Errata

The following corrections are made in “Data Format Classification for Autonomous Radio Receivers,” by M. Simon and D. Divsalar, which appeared in *The Interplanetary Network Progress Report*, vol. 42-159, published on November 15, 2004:

Fig. 1. Reduced-complexity coherent data format classifiers for BPSK: (a) low SNR and (b) high SNR.

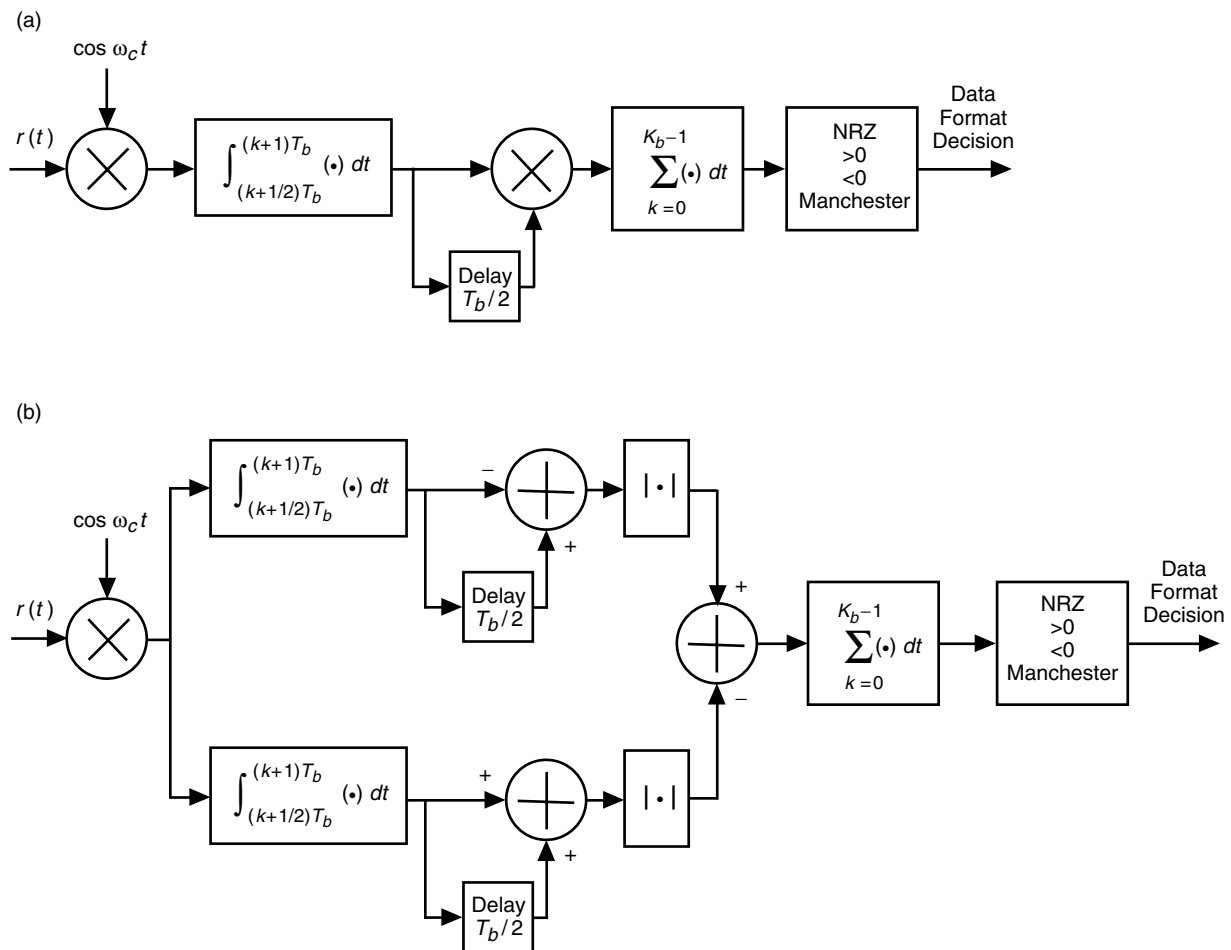
In Figs. 1, 3, and 4 (on pp. 4, 11, and 16), the input to the box labeled “Delay $T/2$ ” should come from the output (as opposed to the input) of the half-symbol integrate-and-dump filter. The corrected figures are as follows:
